# EASTERN CORRIDOR SEGMENTS II AND III (PID 86462) SR 125/SR 32 FOCUS AREA ADVISORY COMMITTEE MEETING NOTES

EASTERN CORRIDOR SEGMENTS II AND III (PID 86462)  
**SR 125/SR 32 FOCUS AREA**  
**ADVISORY COMMITTEE MEETING #1**  
ANDERSON CENTER • FEB. 9, 2018  
9:30 a.m. – 11:30 a.m.

**Figure I-7D**  
 CLOUGH PIKE AND S.R. 32 GREEN TEE INTERSECTION

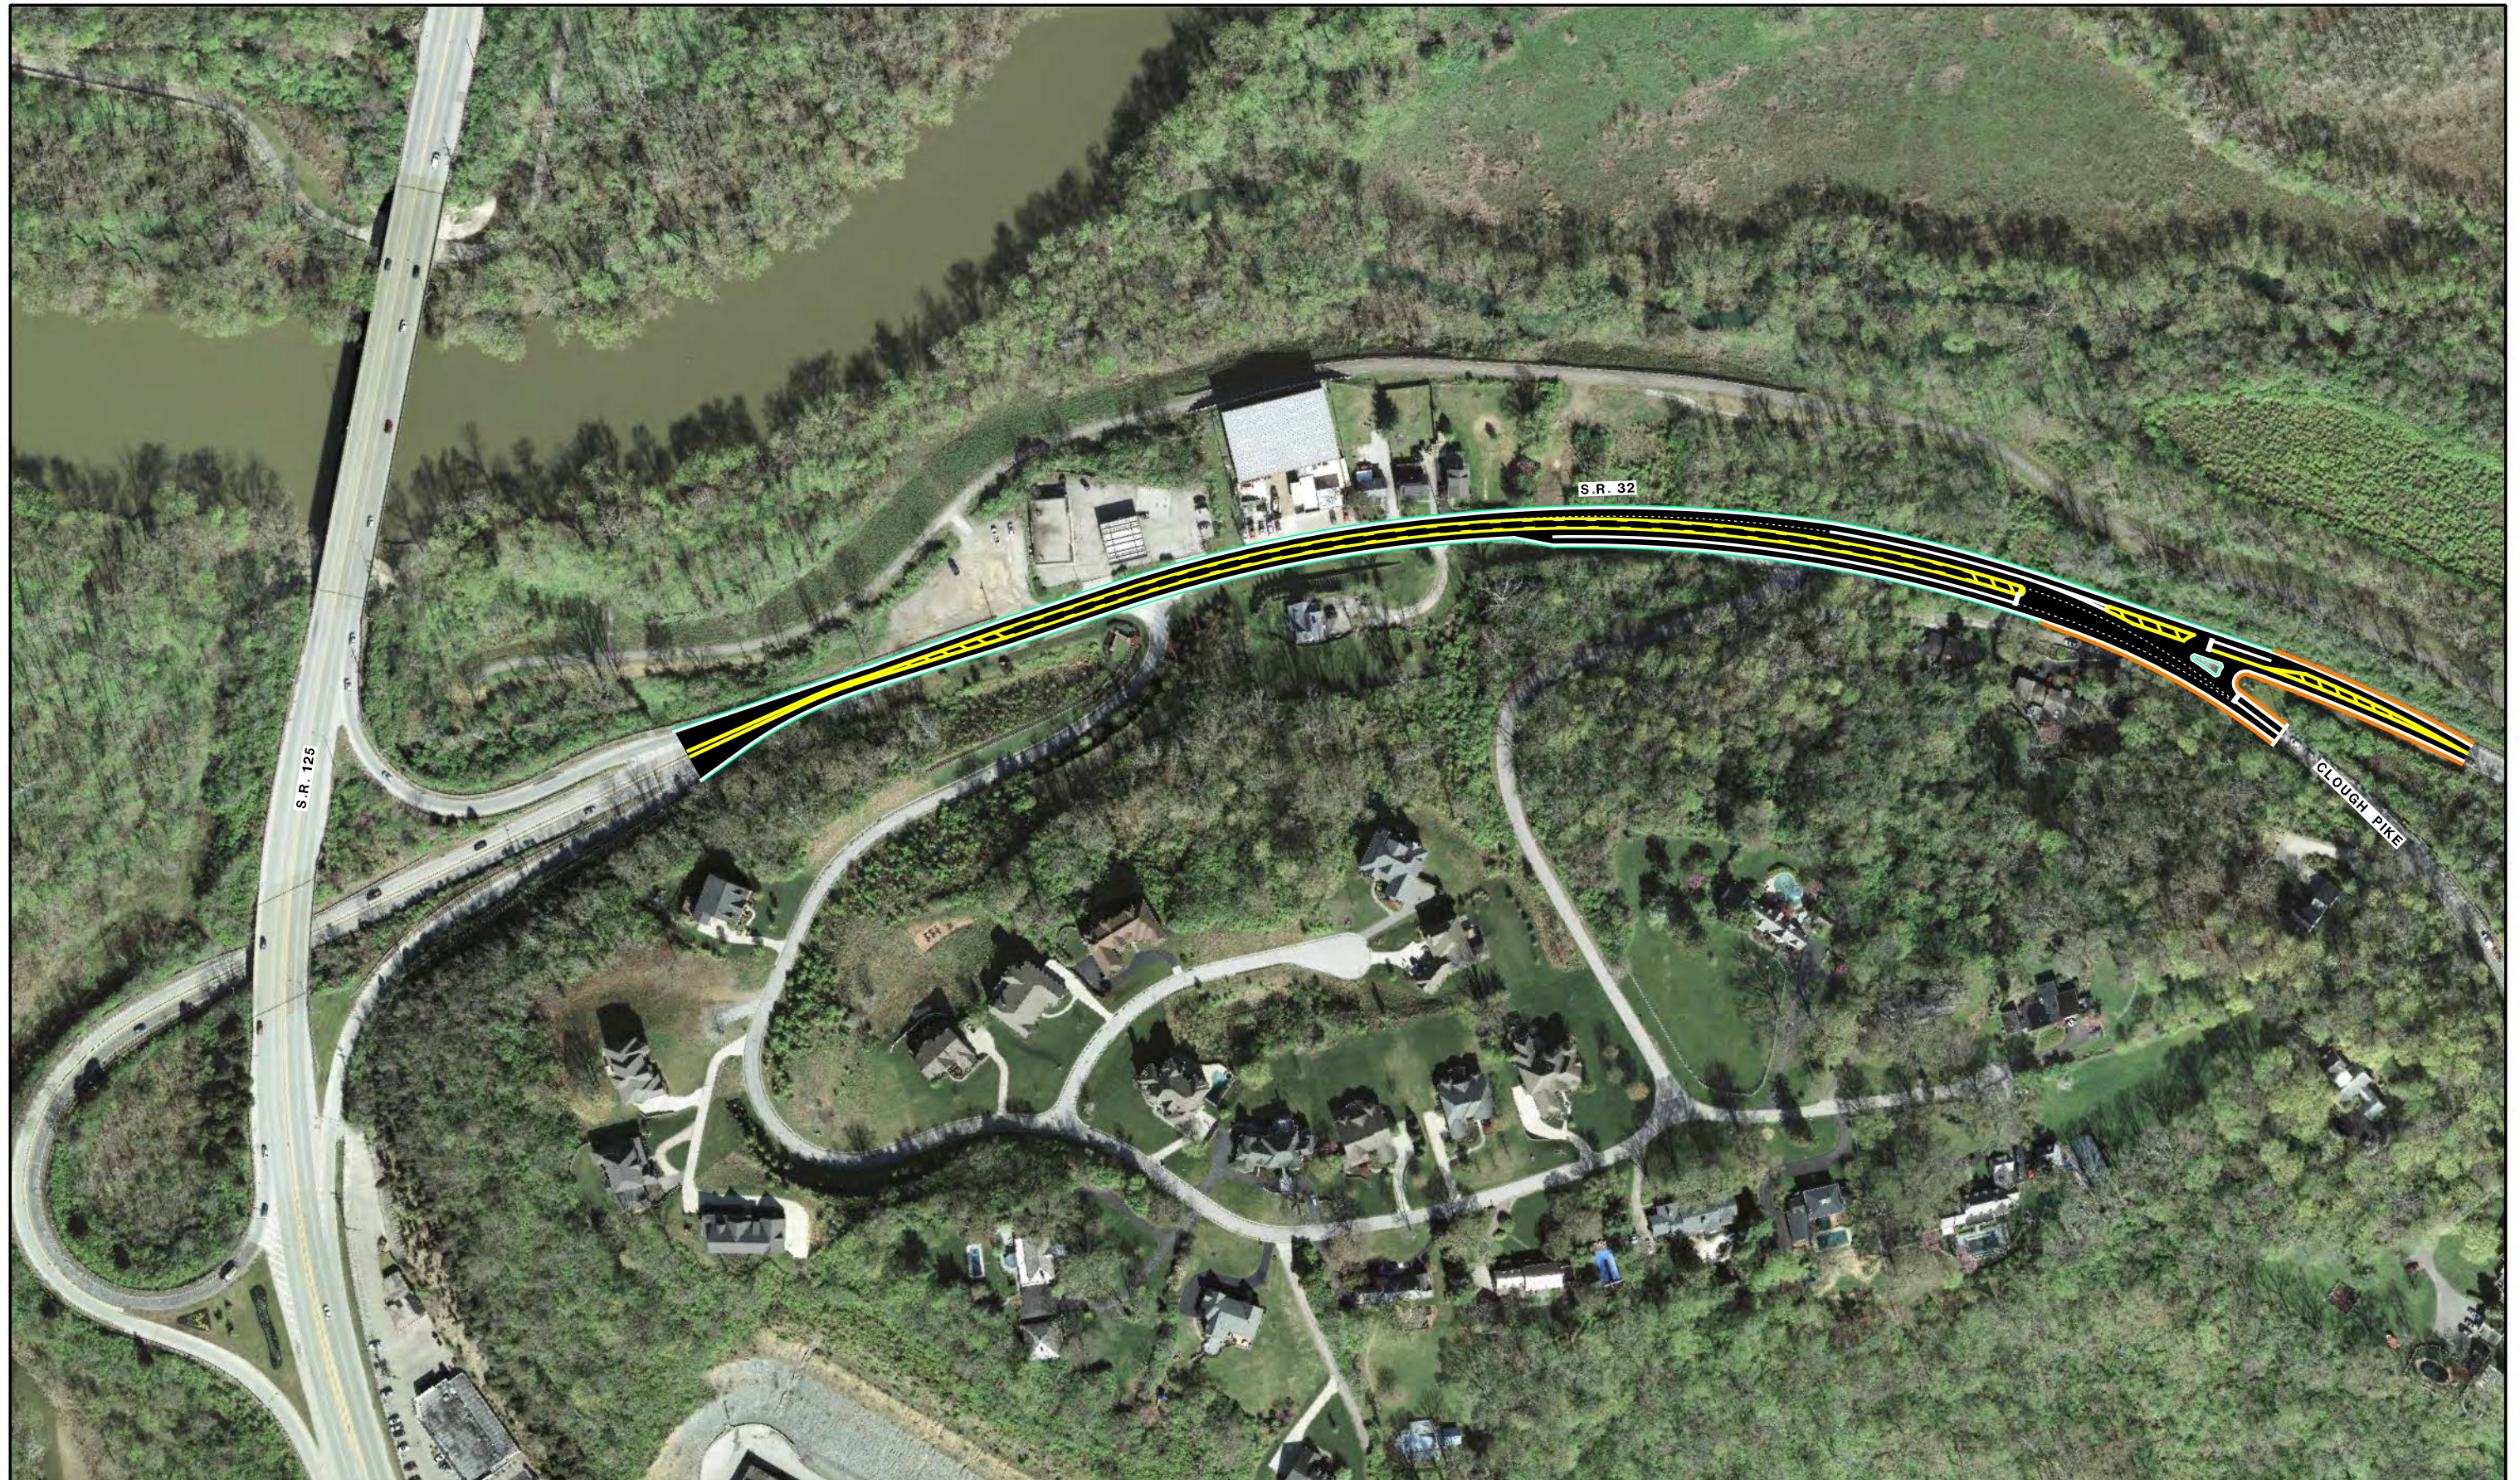
- The committee noted that this concept was generally received favorably by the public (see Public Feedback Ratings Summary, next page), however there was some concern that the project could potentially result in increased travel speeds.
- The committee agreed to designate this concept as a medium priority.

- Include in the Implementation Plan as a medium priority.

**Figure X-1D**  
WESTBOUND THROUGH LANE EXTENDING  
TO WOOSTER ROAD

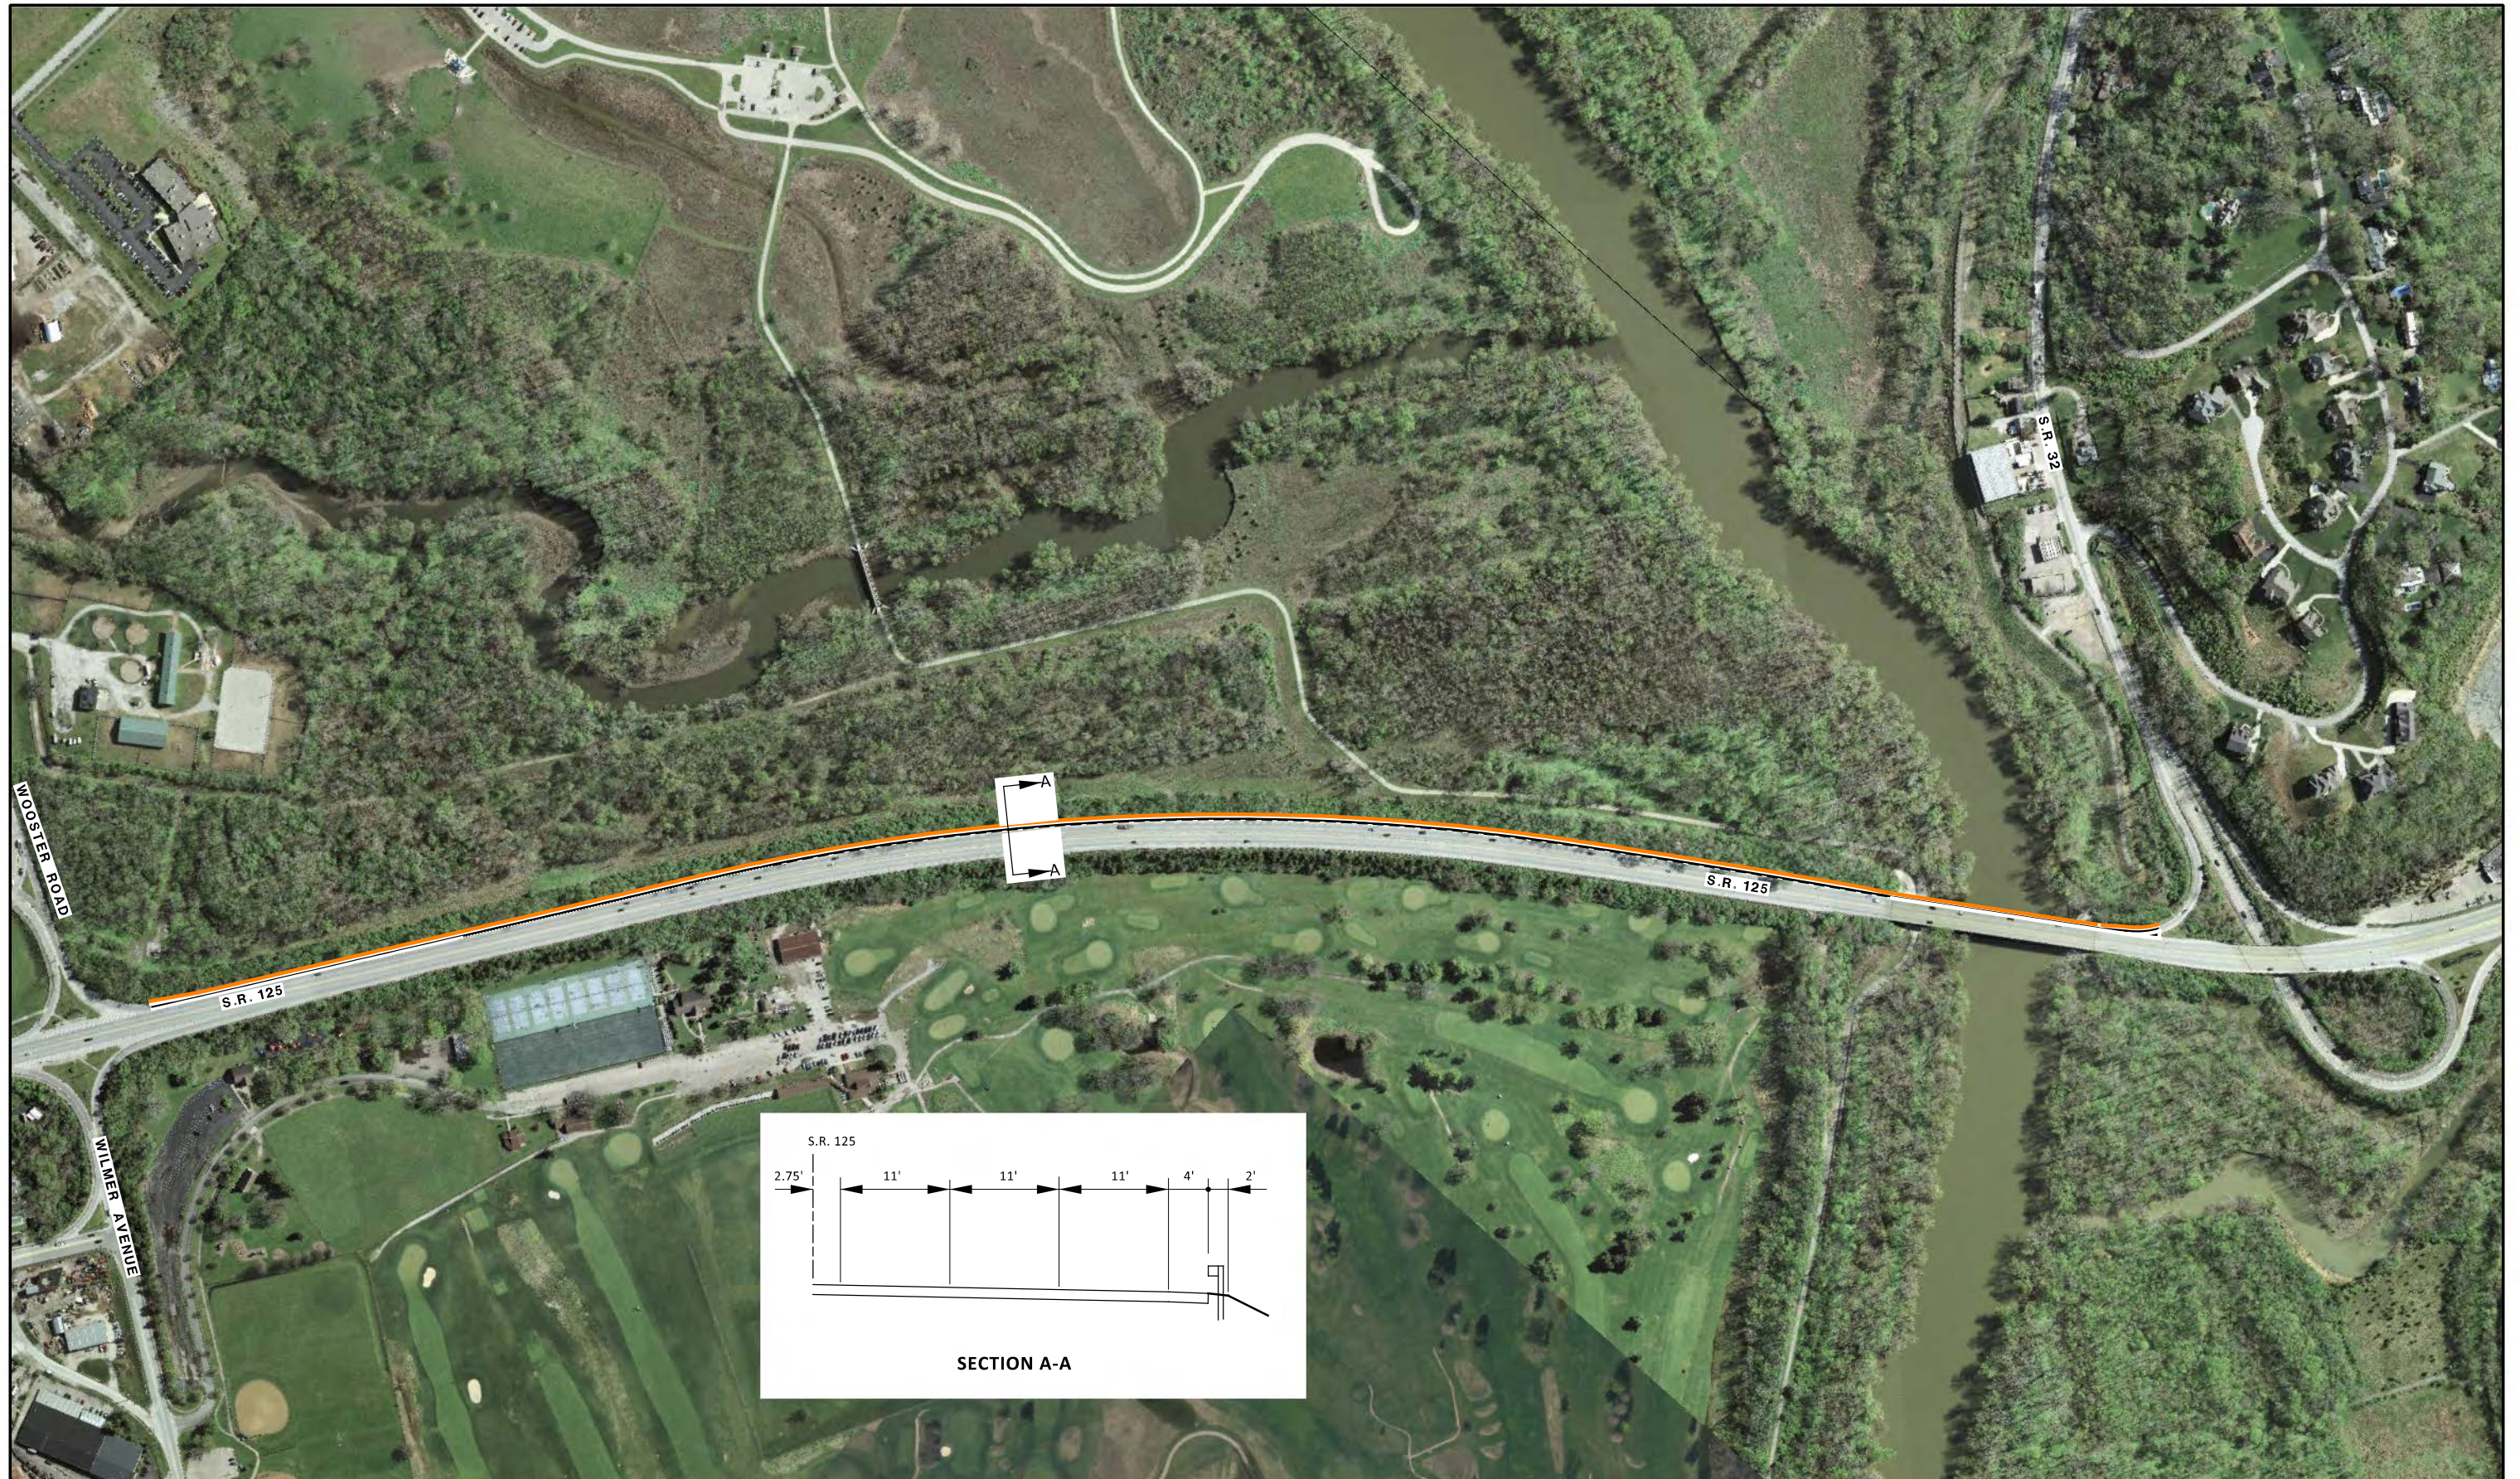
- Room for the new lane can be obtained by restriping the existing pavement (no widening could be needed).
- This work could be incorporated into any project planned along this stretch of SR 125.
- Initial analysis indicates:
  - A 24% decrease in delays during morning peak-hours
  - A 34% decrease in delays during evening peak-hours
- Consultant to conduct a traffic analysis to determine how adding a third lane would impact westbound traffic.
- Consultant will also evaluate the possibility of narrowing the two 12-foot eastbound lanes by one foot to narrow eastbound lane by one foot and provide space to increase one westbound lane by one foot.
- City of Cincinnati DOTE will check to see if any projects are being

- The additional westbound lane would extend between the SR 125 and SR 32 interchange and the intersections of SR 125 and Wilmer and Wooster.
- Some widening of SR 125 would be needed to maintain four-foot shoulders (reducing the width of the shoulders could be a concern when cars break down).
- Committee members felt that the current merging pattern isn’t too problematic and establishing a wider road might encourage faster travel speeds. But, pedestrian and bicyclist needs still must be met.
- Traffic modeling shows that three lanes are not needed; two work sufficiently.
- No additional comments were received following the 8/20 meeting.

- No further study. Traffic modeling shows that there is no need for an additional westbound lane.
